Proton Beam Therapy - Phase 4

VIE - Facade Details - Non Material **Amendment Application** @ A1 BIM FILE NAME Date SCALE 1:10 PROJECT ISSUER AREA LEVEL TYPE TRADE SEQUENCE REV FIRST ISSUE DATE PROPOSED STATUS S2 - Issued for information P4PBT STW VIE SL DET A31 180080 C 22/06/15

Non-Material Amendment Application

VIE - Detail Plan 03 1-10 Non Material Amendment

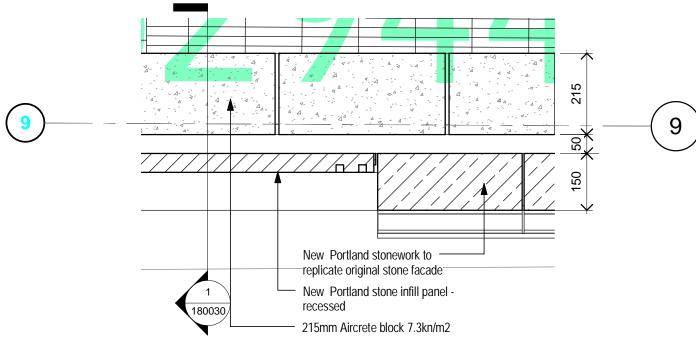
1. Base of the VIE enclosure to be reconstructed

to replicate original external appearance of the

Rosenheim building based on detailed surveys.

2. New brick enclosure may be constructed as a

3. Existing JB PUB gable wall to be externally clad with a new 100mm block work leaf up to VIE

enclosure level. Above the VIE enclosure level

the existing JB PUB gable wall will be externally

clad with a new 100mm brickwork leaf to match

4. Undercroft level below proposed VIE ground floor slab will be a non habitable below ground

chamber and will not be used for storage.

5. Final specification and details of the base

(from ground to base of bricwork level) of the VIE

enclosure will be subject to a further submission.

traditional solid brick construction.

JB PUB brickwork.

VIE - Detail Plan - Brickwork recess 1-10 Non Material 5 Amendment Application

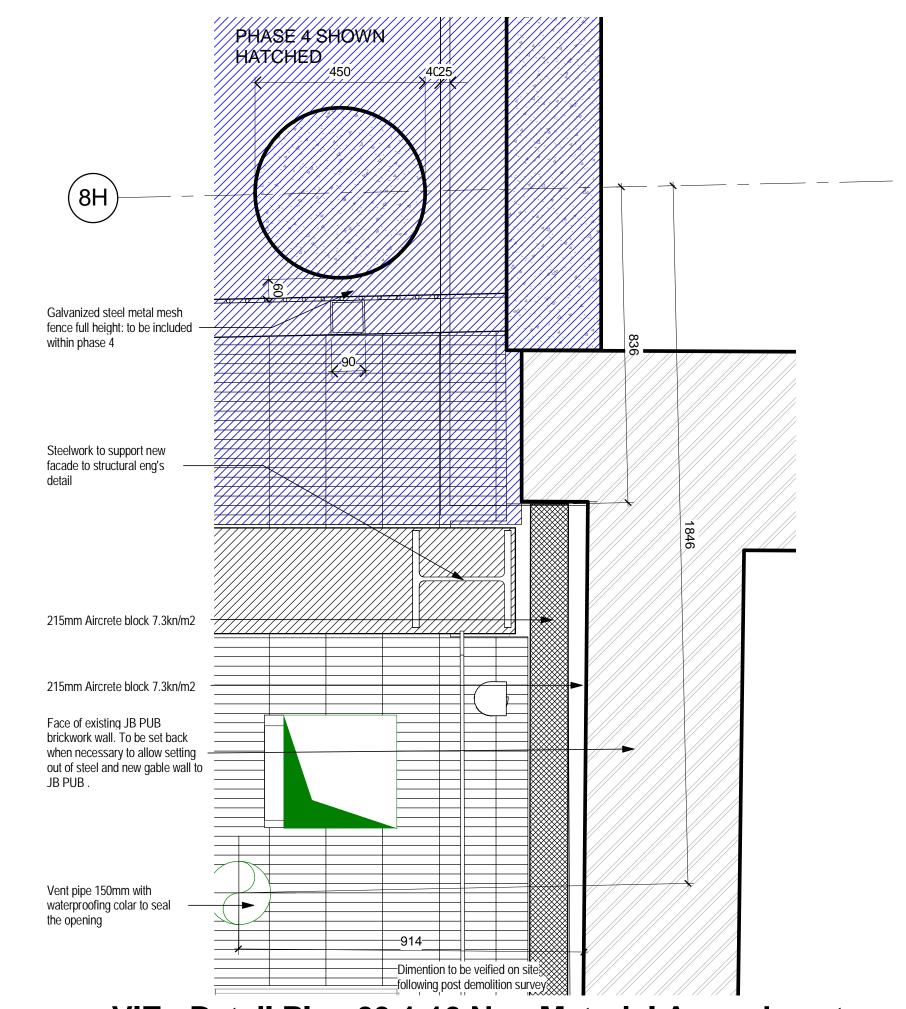
Application 1:10 Secondary frame system (Metsec SFS - or equal and approved) fixed to steelwork, verticals at max. 600mm centres. Brick tie restraint channels fixed to secondary steel verticals with s.s. screws. Brick ties at max. 450mm centres vertically. Final design and detail of secondary frame and brickwork support to be by specialist. 9 Portland stonework to replicate original stone facade Single skin brickwork recess - bricks to match those of the demolished Rosenheim Single bullnose to base of recess Double skin brickwork - to match those of the demolished Rosenheim building
